INTERFACE REVISION NOTICE

INTERFACE CONTROL DOCUMENT

ICD NO. LID-340-10000

ICD TITLE
PGNS (LGC-CDU-PSA and Signal Condition Installation

Figure 5 Interface Schematic

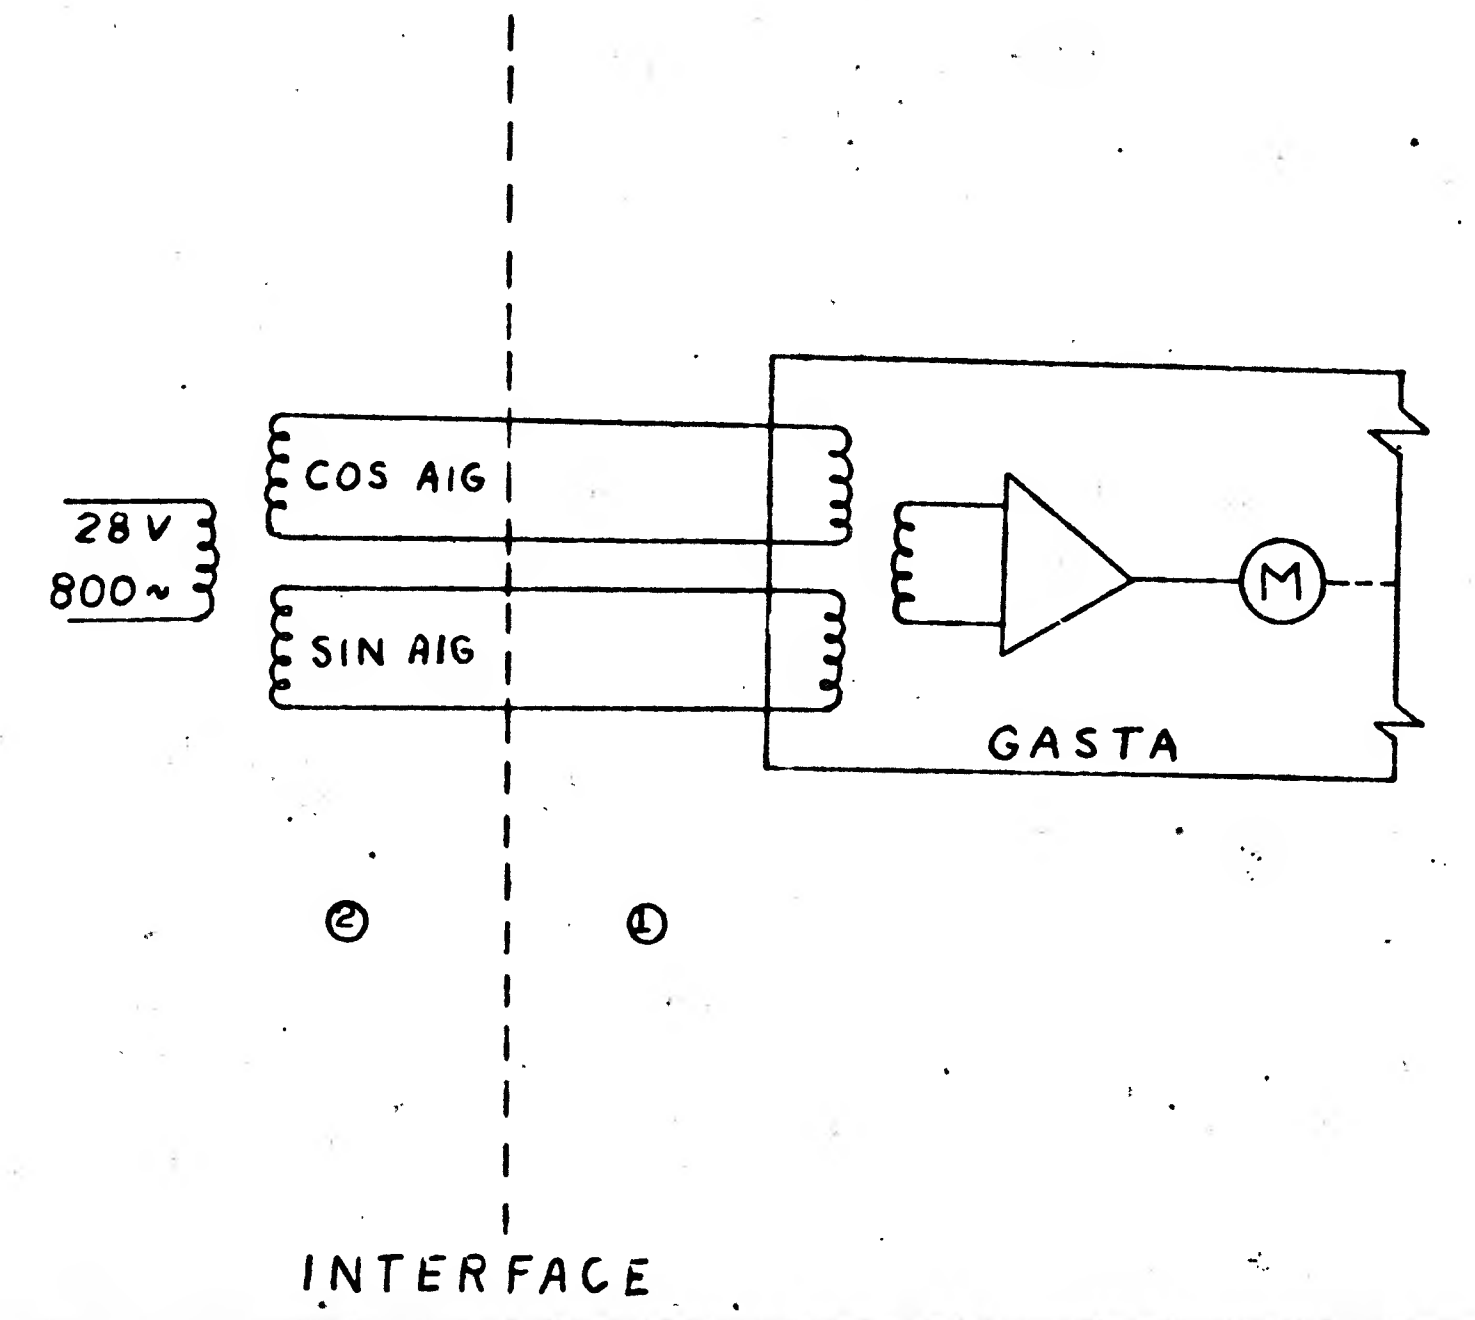
Sheet 9: Figure 5: Add "For Reference Only."

⑮ DETAIL C ENVELOPE DIMENSIONS & MOUNTING HOLE LOCATIONS FOR PSA & G&N SIGNAL CONDITIONER (MIT-124994)

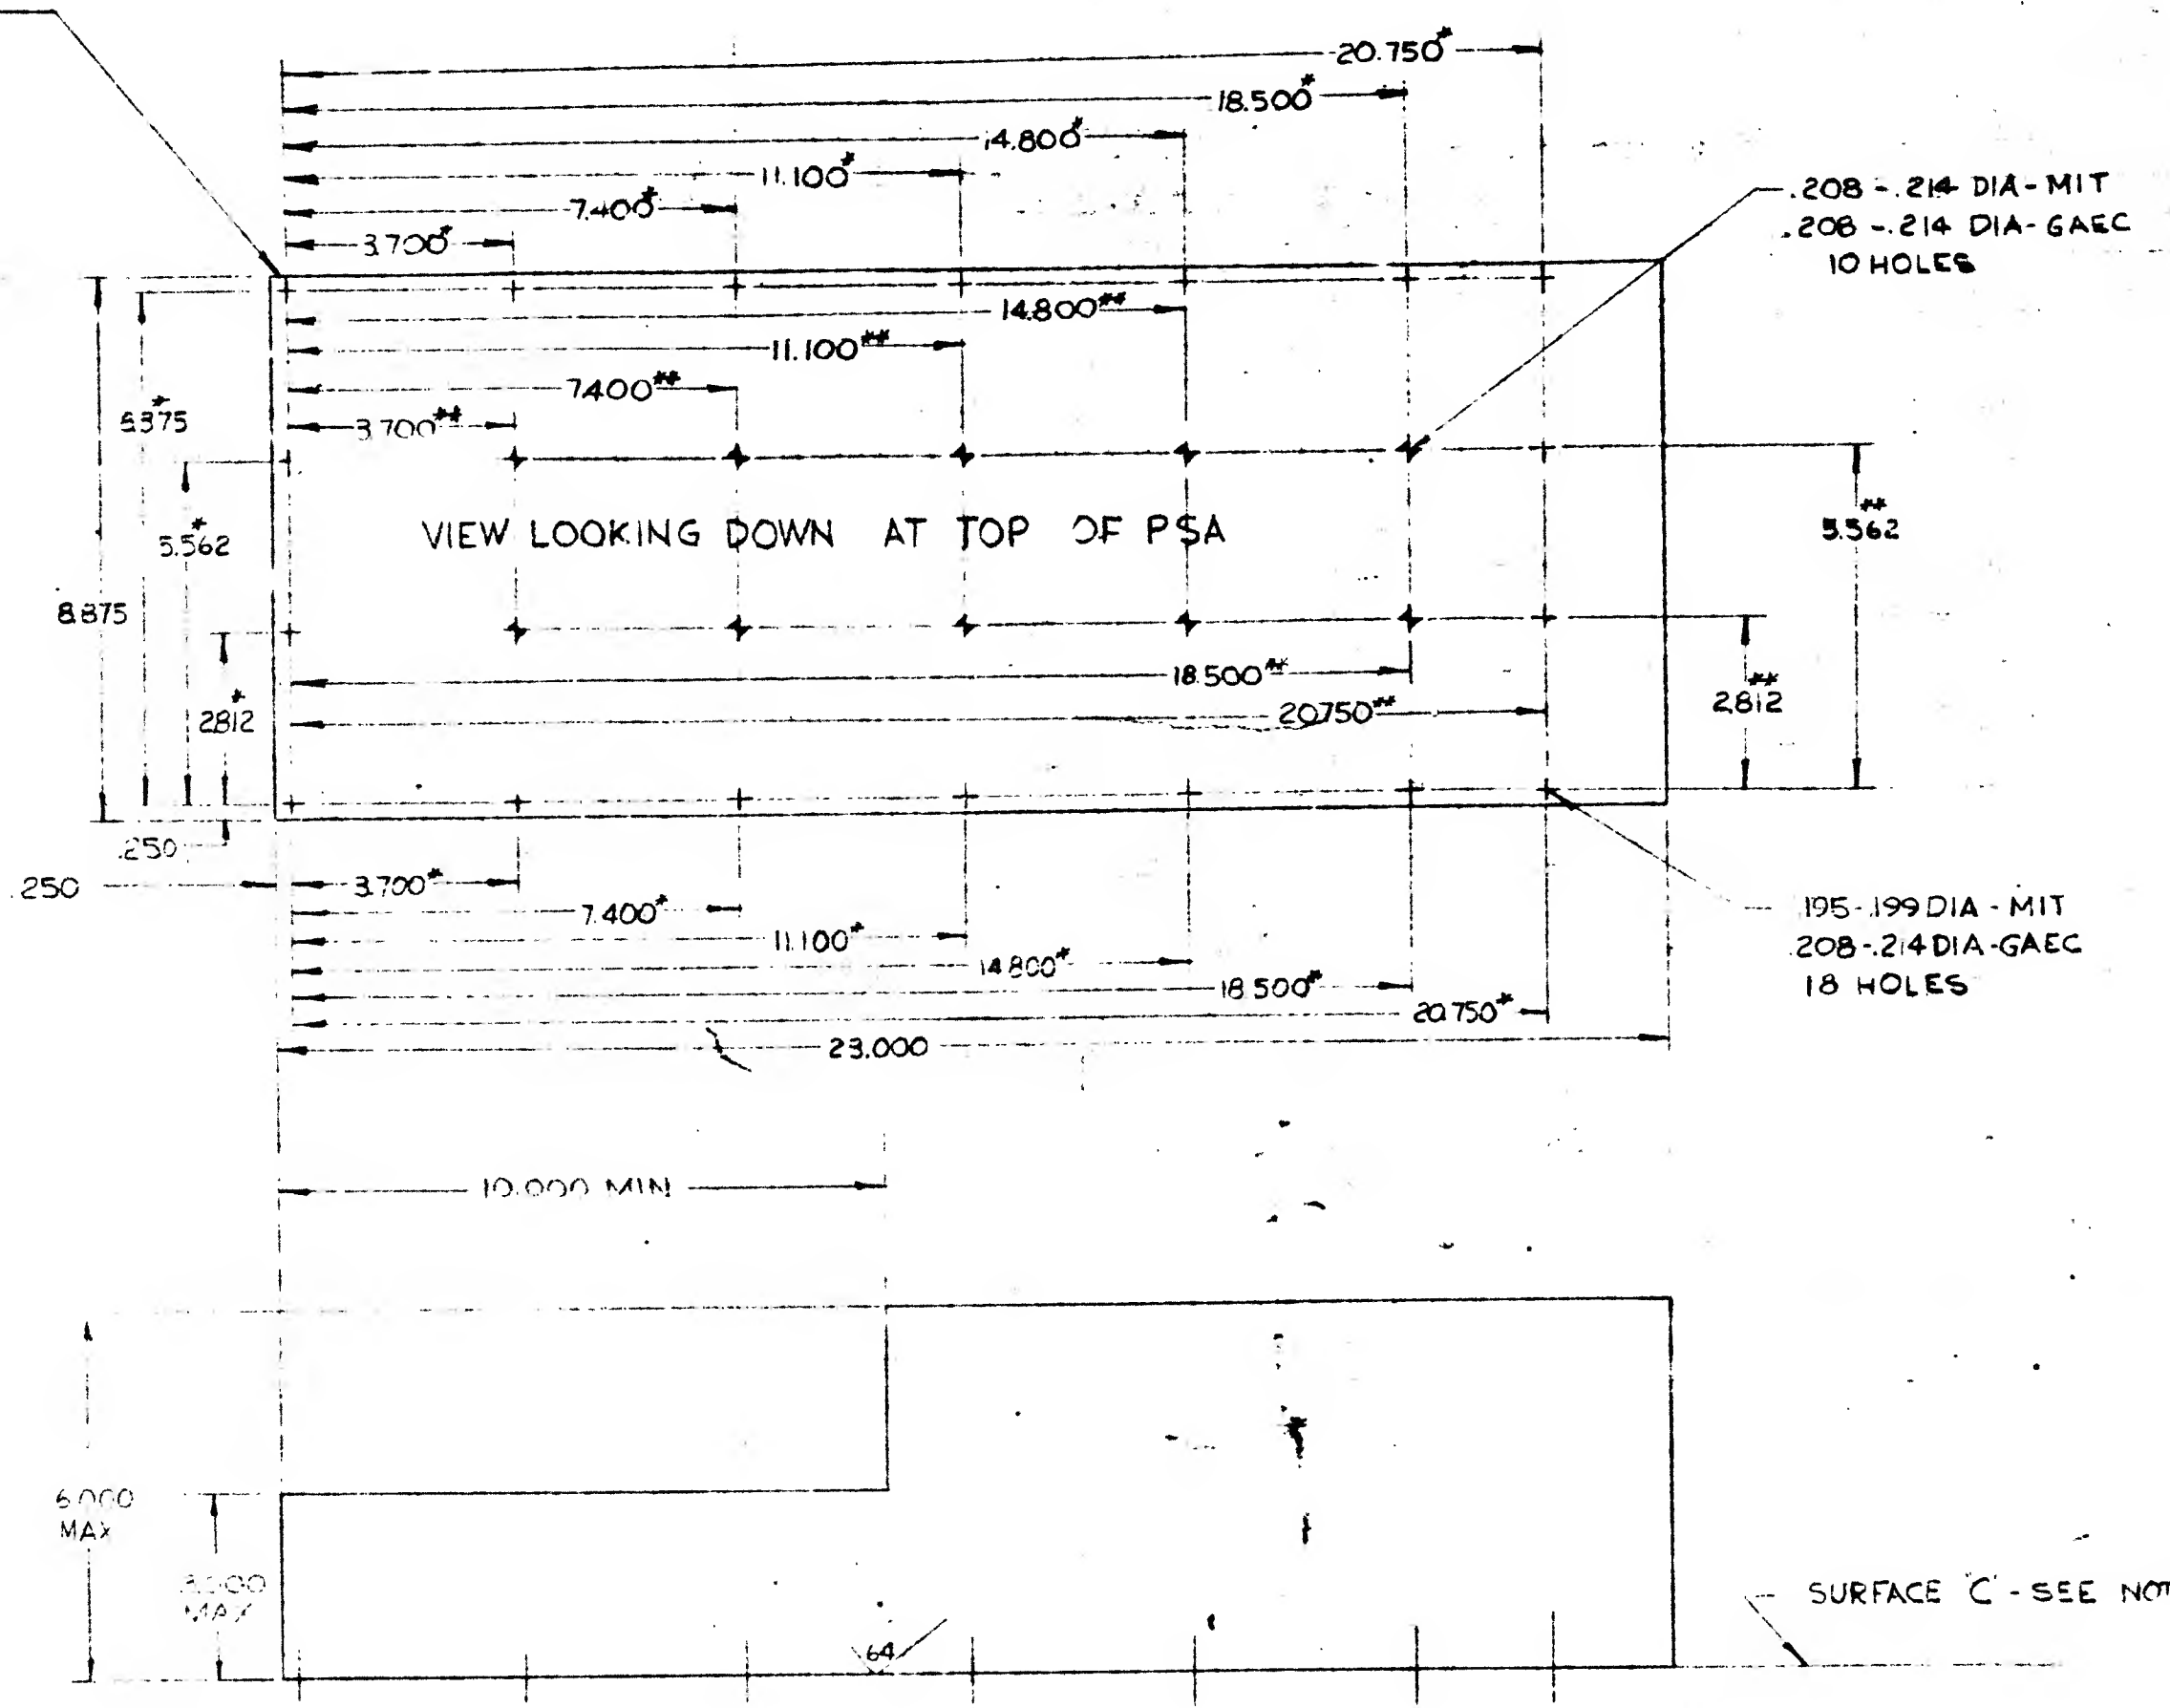
3. Zone 5: Change callout note from: "Fasten PSA & G&N Signal Conditioner (MIT 124994)" to: "Fasten PSA (6007200) & G&N Signal Conditioner (6007010)".
4. Zone 10: Change CDU length from: "20.562 max." to: "20.250".
5. Zone 12; Detail C: Change title from: "...for PSA & G&N Signal Conditioner (MIT-124994)" to: "...for PSA (6007200) & G&N Signal Conditioner (6007010)". Change PSA length from: "23.000" to: "23.325". Correct picture of the two views accordingly.

REASON: (a) Update assembly part numbers. (b) Change from maximum to nominal on CDU length. (c) Add .325" to connector end of PSA to increase spare pin margin and permit addition of module at one end of connector, if required.
